Docket No. 50-320

In the Matter of	)	
	)	
GENERAL PUBLIC UTILITIES NUCLEAR	)	Docket No. 50-320
CORPORATION	)	
(Three Mile Island Nuclear Station,	)	
Unit 2)	)	(10 C.F.R. 2.206)

DIRECTOR'S DECISION UNDER 10 C.F.R. 2.206

Issuance of Director's Decision Under 10 C.F.R. 2.206

REACTOR & SERVICE STRUCTURE

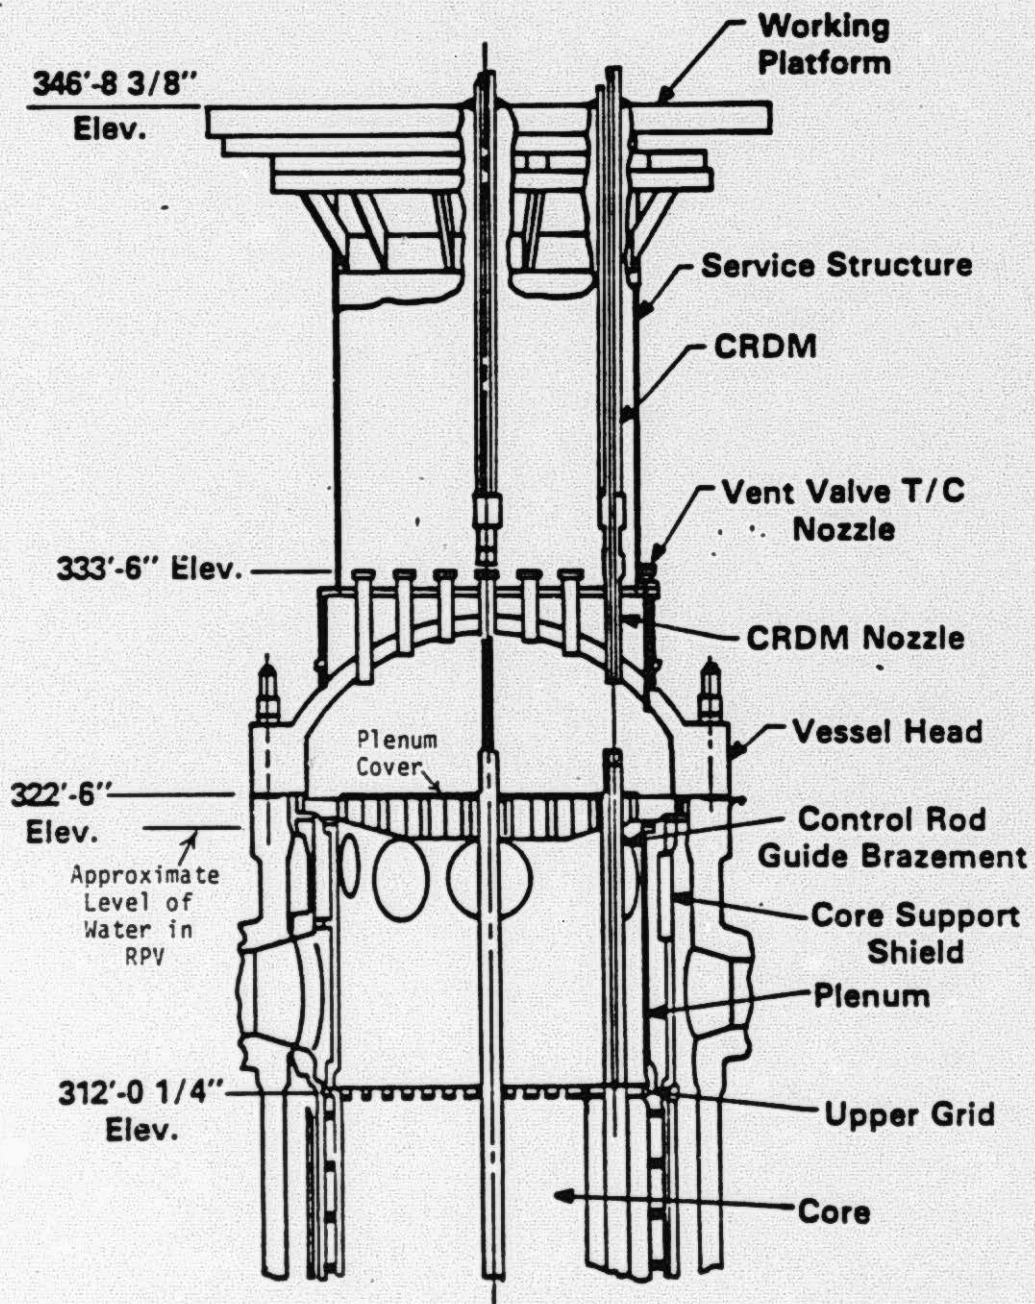
In addition to the pyrophoricity tests described above, the licensee performed chemical analyses of solids filtered from the reactor coolant system and of the thin films scraped from the surfaces of the control rod drive mechanism (CRDM) leadscrews removed from the reactor vessel head. See Figure 1. These analyses indicated the absence of zirconium metal and hydride particles. Based on the visual examinations, analyses and tests which indicate the probable absence of pyrophoric materials on the plenum cover, the NRC approved the lowering of the RPV water level to approximately one foot below the plenum surface, which enabled the licensee to proceed with the underhead characterization effort. The water was lowered to this level to simulate the radiological conditions that will exist for

the RPV head lift. As a result, the plenum cover has been exposed to air since August 20, 1983, without any adverse impact. This condition has been visually confirmed by closed circuit television inspection conducted subsequent to the lowering of the water level. Additionally, the six samples which were removed from the core debris bed have been exposed to air for several months with no indication of pyrophoric reactions.

The information resulting from the visual observation of the plenum and the analyses and tests on materials removed from within the RPV indicates that: (1) little material is present on the plenum surface, (2) the material on the plenum surface is not pyrophoric, (3) material filtered from the reactor coolant system during the accident lacks any pyrophoric content, (4) material scraped from CRDM leadscrews lacks any pyrophoric content, and (5) samples of material removed from the damaged core have not shown any tendency to undergo a pyrophoric reaction. Accordingly, the staff concludes that there is little potential for a pyrophoric event with the plenum cover exposed to air. The information provided by Mr. Lewis and Professor Gulbransen is of a general nature concerning pyrophoricity and the dangers that phenomenon poses for the head lift. The staff does not disagree with the petitioner that pyrophoric conditions could have developed in the RPV following the TMI accident. For that reason, prior to the receipt of the petition, the staff considered the issue of pyrophoricity as it relates to the licensee's proposed Underhead Characterization Study. Based upon the staff's reviews and the experience to date as described above, there does not appear to be an undue risk to public health and safety from the possible formation of pyrophoric materials in the pressure vessel.

With regard to Mr. Lewis' and Professor Gulbransen's cautions about proceeding with the RPV head lift on the basis of pyrophoricity concerns, it should be noted that the water level in the reactor vessel is presently at one foot below the plenum cover. This level is precisely that planned for the RPV head lift. No further lowering of the water level is contemplated for the RPV head lift. Thus, no further safety review of pyrophoric issues as related to the head lift is warranted. Moreover this issue has been addressed by actual experience along with evaluations, analyses, tests, and activities performed in connection with the Underhead Characterization Study.
